STAFF RECOMMENDATION
1903 Linden Avenue
July 18, 2012

Application: New construction-addition
District: Belmont-Hillsboro Neighborhood Conservation Zoning Overlay
Council District: 18
Map and Parcel Number:
Applicant: Manuel Zeitlin, architect
Project Lead: Robin Zeigler, robin.zeigler@nashville.gov

<p>Description of Project: Applicant proposes a two-story addition that wraps the left corner and the redesign of an existing non-historic porte cochere on the right side.</p> <p>Recommendation Summary: Staff recommends approval with the conditions that:</p> <ul style="list-style-type: none">• The applicant provide information about the material, design and dimensions of masonry, foundation, windows, doors, roofing, trim and railings; and• The right/rear addition only wrap the basement and first levels with a bay on the second level to accommodate the stairwell, as long as the entire addition stays below the existing eave. <p>With these conditions, the project meets the design guidelines for the Belmont-Hillsboro Neighborhood Conservation Zoning Overlay.</p>	<p>Attachments A: Photographs B: Site Plan D: Elevations</p>
---	--

2 NEW - GROUND LEVEL
1/8" = 1'-0"

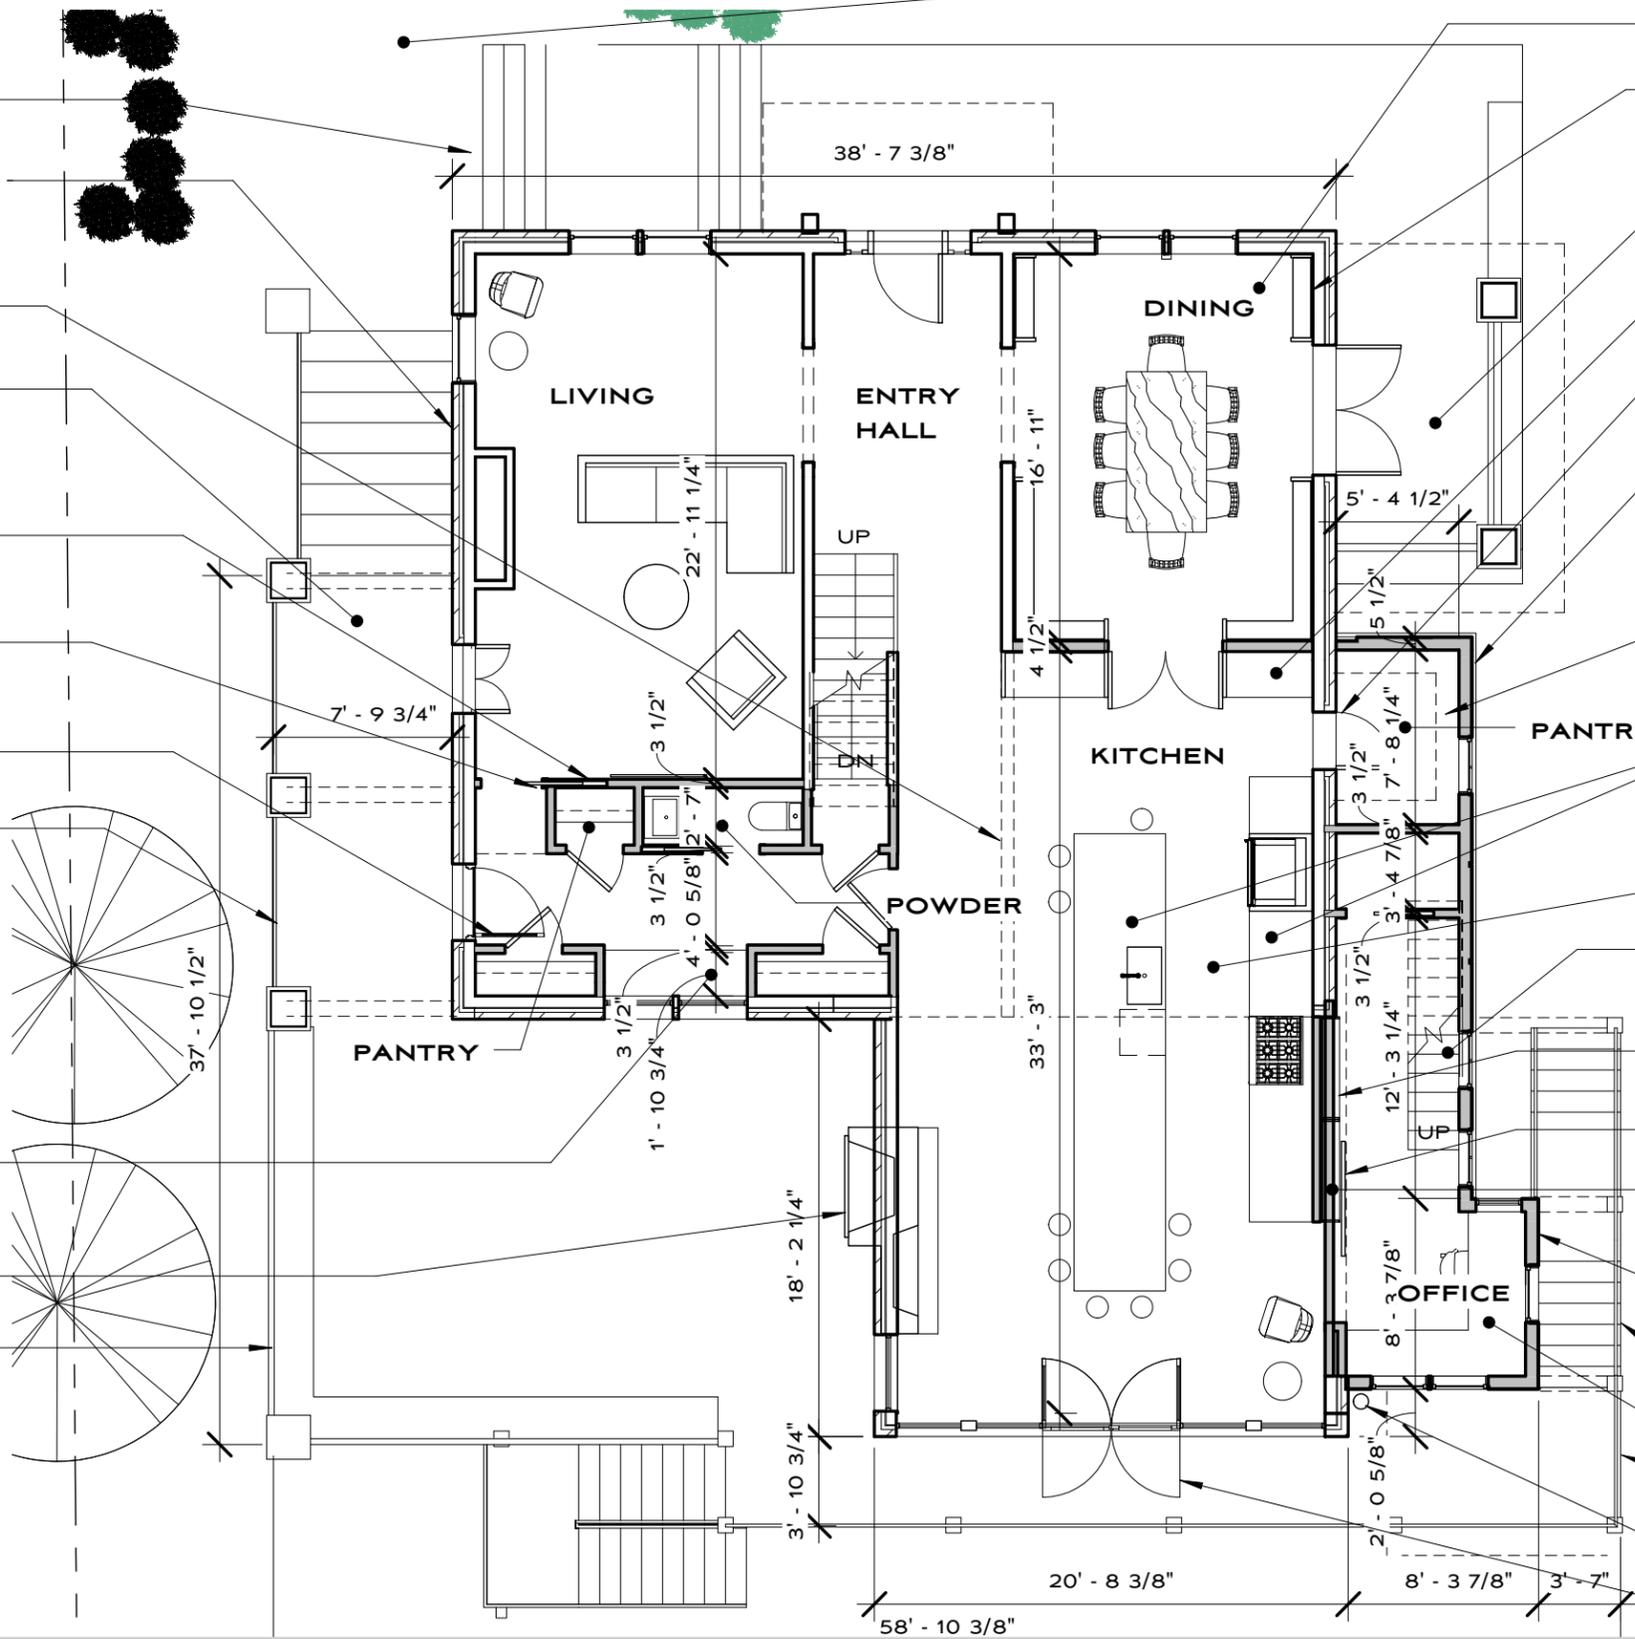
1) The right side of the home has an existing non-historic porte cochere with uncovered deck above. This element is too low to be used for modern vehicles so it will be rebuilt with stairs leading up to the deck area that is level with the first floor of the house and with an enclosure for the lower section. The uncovered deck area will become a covered porch with traditional battered posts on pedestals but with a more contemporary shed roof porch cover that will help to distinguish the old from new. Since this will improve a non-historic element, this side addition meets the design guidelines.

1) The heights of the right addition is appropriate as the foundation line will match the existing foundation line and the porch roof will be below the second level

- windows. The right side addition does not add to the footprint of the house and is in the same location as the existing porte cochere.
- 2) Overall the height of the left/rear wrap is appropriate as the foundation line (noted with a trim board) matches the existing foundation line and the addition sits below the eave of the existing house. The rear right corner addition adds approximately 224 square feet to the existing footprint, reducing the percentage of open space by a minimal amount.

2 NEW - UPPER FLOOR
1/8" = 1'-0"

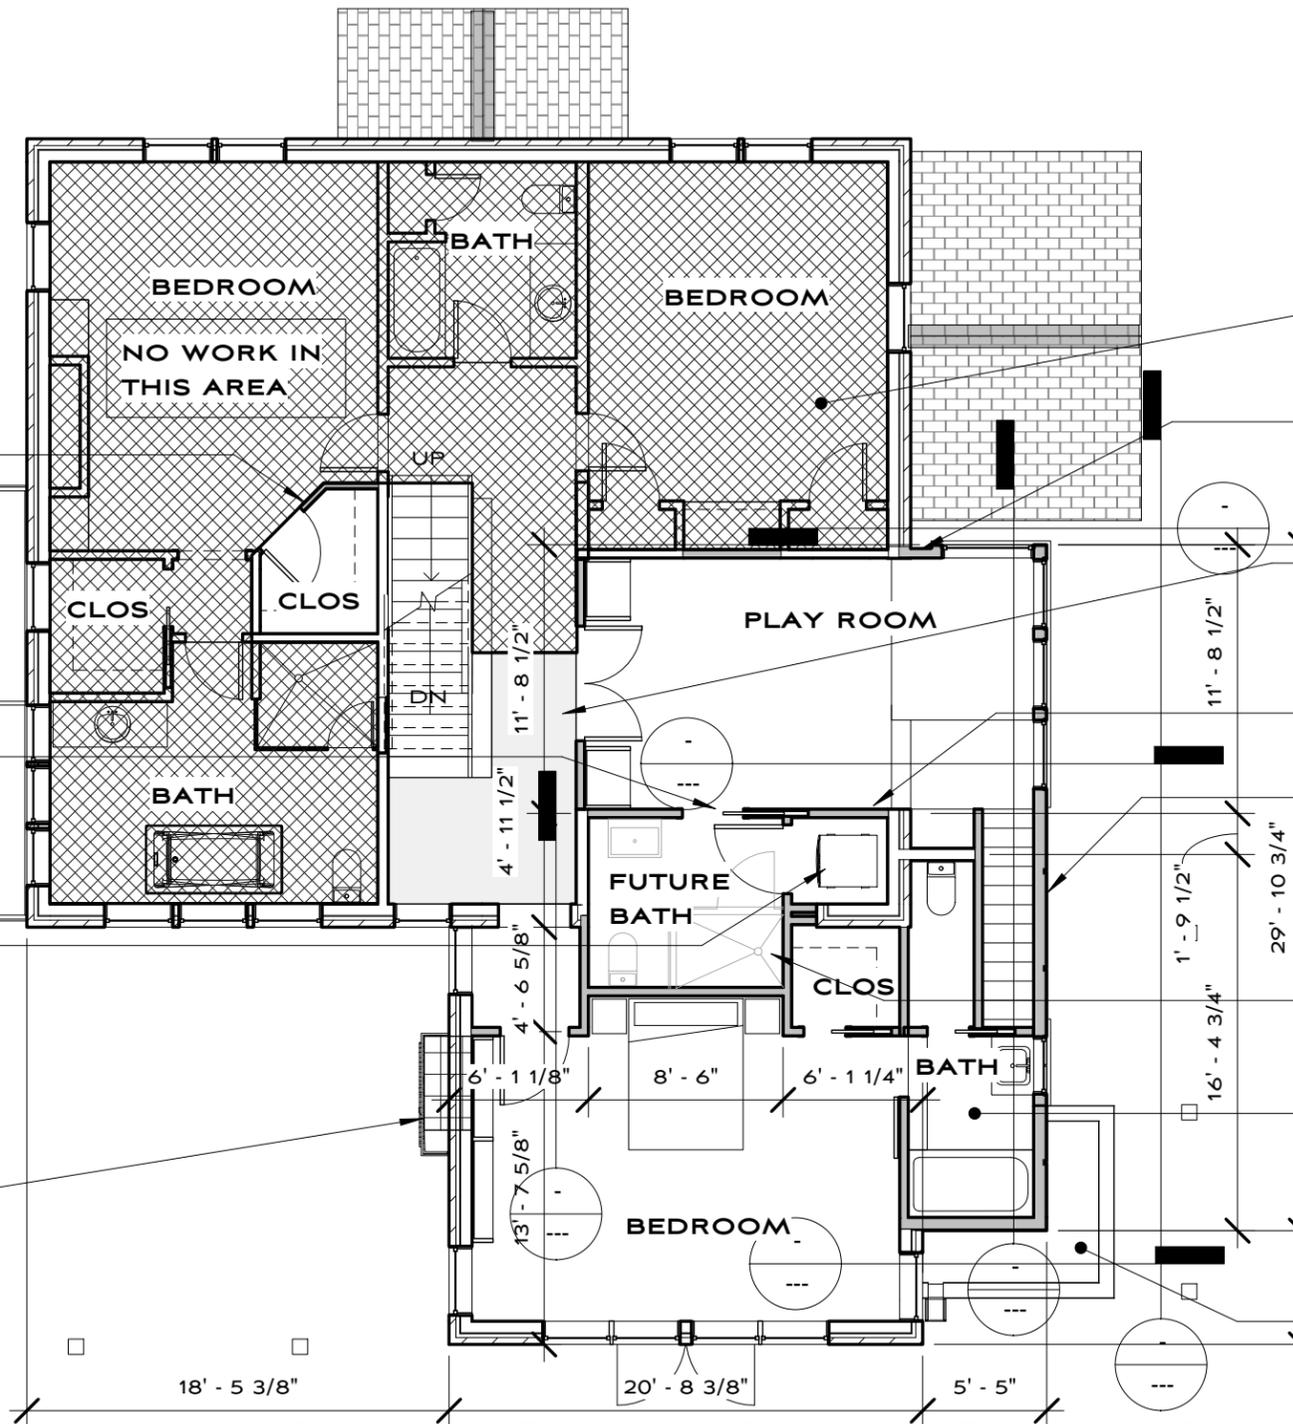
2) The left side addition will be two-stories that wrap the rear corner of the house, behind the existing side porch. According to the design guidelines, an addition should be situated at the rear of a building in such a way that it will not disturb either front or side facades. There have been cases where the Commission has approved side additions alone and a few cases where they have approved additions that wrap the rear corner, as proposed here. At the most recent annual review of cases, the Commission expressed concern with approving additions that are extend to the rear and the side, while wrapping the corner and thereby changing the form of the house. At that time, they

Since this is a two-story house, an addition that wraps just one level would allow the original form to remain evident. In addition, the existing side porch would greatly obscure the visibility of a one-story addition. Staff recommends removal of the left side addition on the second level and the use of a bay to accommodate the stairwell on the second level, as long as the addition remains below the existing eave.

Connection: The connection will wrap the full left /rear corner which alters the original form of the house and makes the addition more difficult to remove. Staff recommends that the addition only wrap on the first and basement levels and a side bay be added to the second level to accommodate the stairs for the project to meet II.B.2.d.

- The applicant provide information about the material, design and dimensions of masonry, foundation, windows, doors, roofing, trim and railings; and
- The right/rear addition only wrap the basement and first levels with a bay on the

second level to accommodate the stairwell, as long as the entire addition stays below the existing eave.
With these conditions, the project meets the design guidelines for the Belmont-Hillsboro Neighborhood Conservation Zoning Overlay.
